Technical review on the boron treatment of LVL to meet H1.2 conditions
in New Zealand

Date: 29 June 2016

Client: Ministry of Business, Innovation and Employment, Wellington,
New Zealand.

The objective of this review was to examine the decision that J-Frame (H1.2 boron treated LVL) as produced by Juken New Zealand Ltd (JNL) complies with the B2 durability provisions of the New Zealand Building Code. CodeMark compliance was provided for the product by AssureQuality in 2015 in their Product Certificate Aq-180615-CMNZ.

Figure 5. Boron penetration in 90 x 45 mm J-Frame. The darker red areas show boron penetration, while the paler yellow areas show a lack of penetration. From Simpson and Singh (2016).

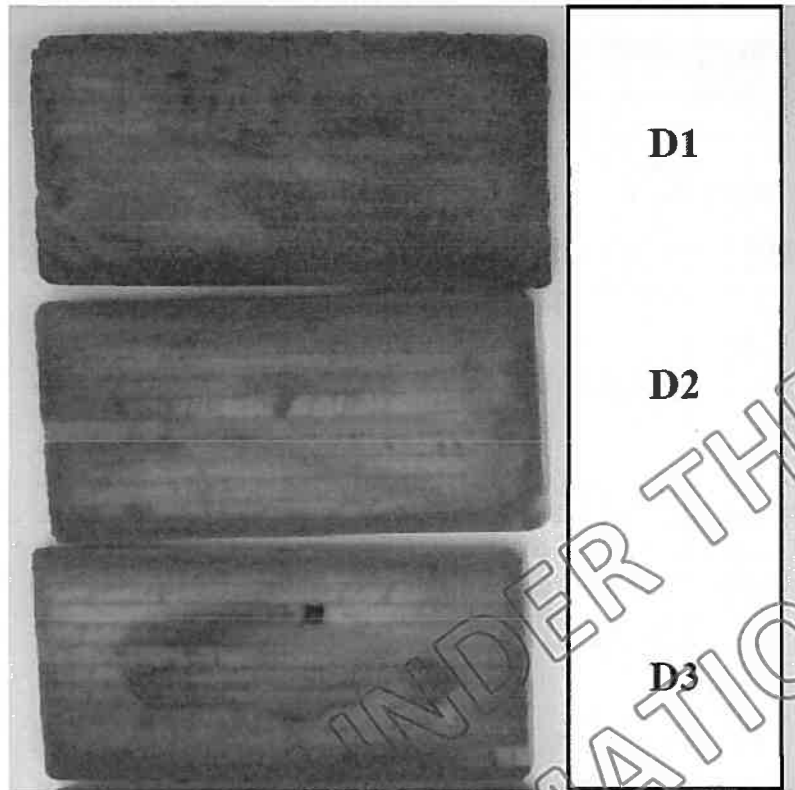
An example of the penetration obtained in the Scion samples was provided in its appendix, and those for samples D1-D3 are replicated in Figure 5. D1 appears to be fully penetrated. However, some of the interior veneers in D2 and D3 have limited penetration.

While JNL is justified in using 'evidence of distribution' to determine penetration in J-Frame and obtain CodeMark approval, the phrase is too weak to ensure durability. Decay may begin on the edge of a veneer that has limited penetration. Also, if J-Frame is cut or machined after treatment, then unpenetrated sapwood could be exposed and will be susceptible to decay. A similar problem was demonstrated in glulam treated after gluing with light organic solvent preservatives (Cookson, 2013). Therefore, a Verification Method should also be used to test the durability of J-Frame under H1.2 conditions to prove its B2 durability. A similar opinion was provided by s 9(2)(a) on 5 August 2015 where penetration and retention 'require underpinning by efficacy trials that demonstrate comparable decay resistance performance of H1.2 LVL.' The final proof of what works will be obtained from durability trials, rather than untested penetration pattern specifications.

Figure 7. Boron penetration in 90 x 45 mm J-Frame. The darker red areas show boron penetration, while the paler yellow areas show a lack of penetration. From Simpson and Singh (2016).

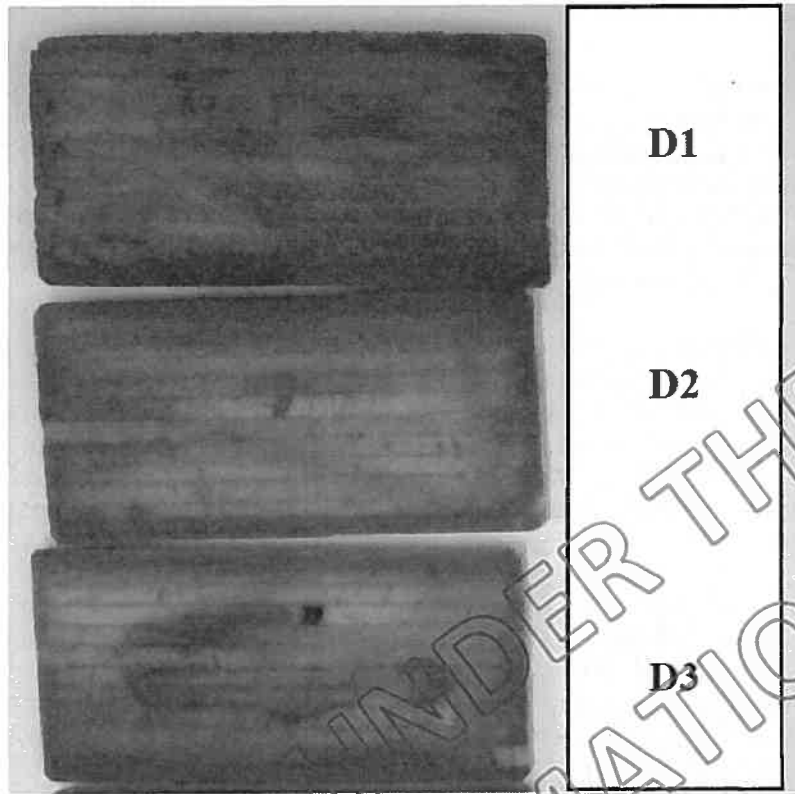
An example of the penetration obtained in the Scion samples was provided in its appendix, and those for samples B1-D3 are replicated in Figure 7. D1 appears to be fully penetrated. However, some of the interior veneers in D2 and D3 have limited penetration (yellowish colouration), although it is not clear whether the cause is unpenetrated heartwood or sapwood.

Figure 7. Boron penetration in 90 x 45 mm J-Frame. The darker red areas show boron penetration, while the paler yellow areas show a lack of penetration. From Simpson and Singh (2016).

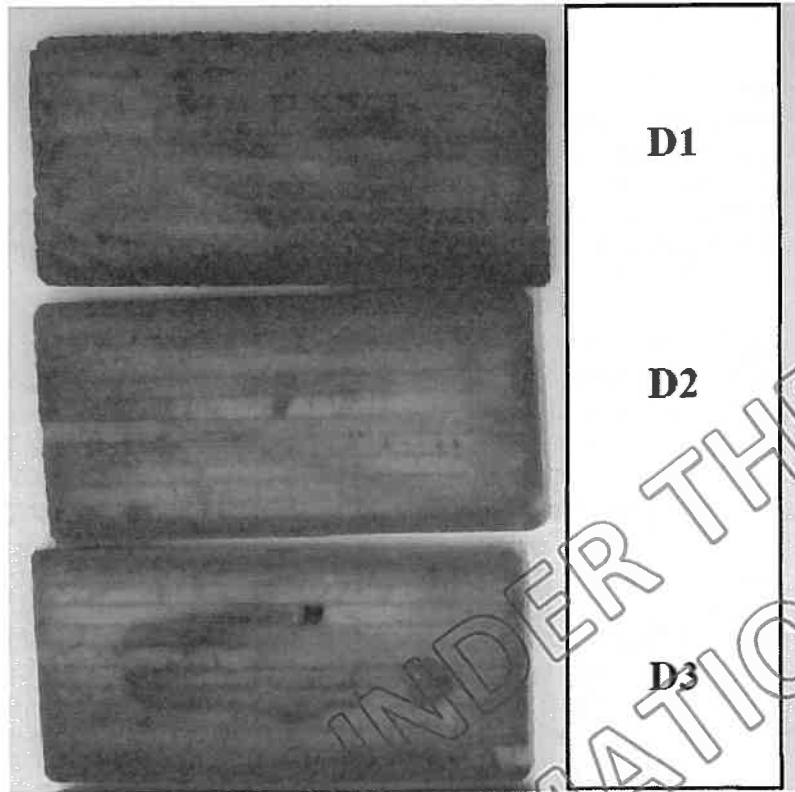
An example of the penetration obtained in the Scion samples was provided in its appendix, and those for samples D1-D3 are replicated in Figure 7. D1 appears to be fully penetrated. However, some of the interior veneers in D2 and D3 have limited penetration (yellowish colouration), although it is not clear whether the cause is unpenetrated heartwood or sapwood.

Figure 7. Boron penetration in 90 x 45 mm J-Frame. The darker red areas show boron penetration, while the paler yellow areas show a lack of penetration. From Simpson and Singh (2016).

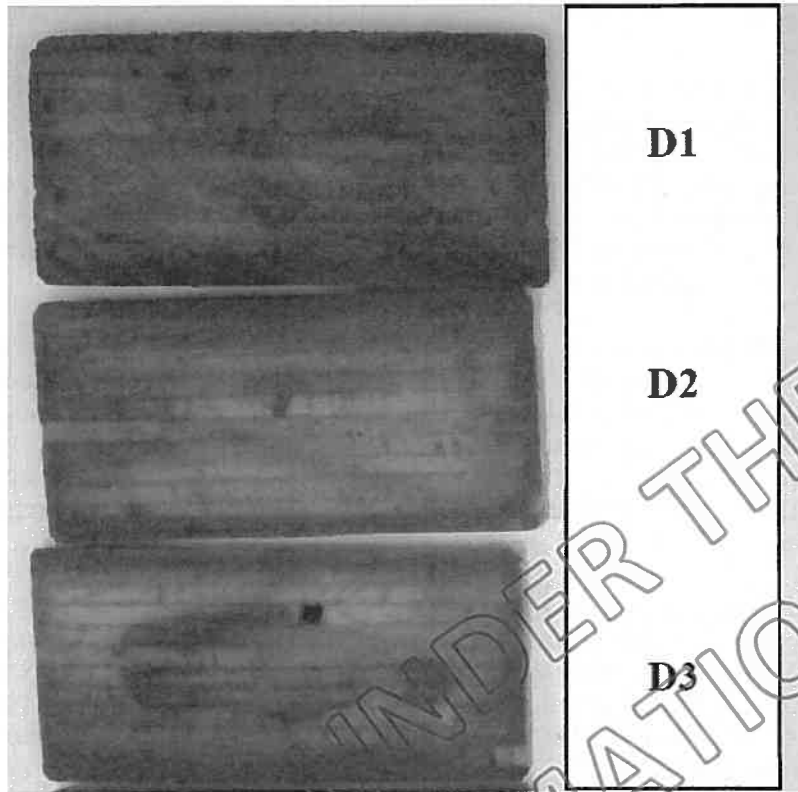
An example of the penetration obtained in the Scion samples was provided in its appendix, and those for samples B1-D3 are replicated in Figure 7. D1 appears to be fully penetrated. However, some of the interior veneers in D2 and D3 have limited penetration (yellowish colouration), although it is not clear whether the cause is unpenetrated heartwood or sapwood.
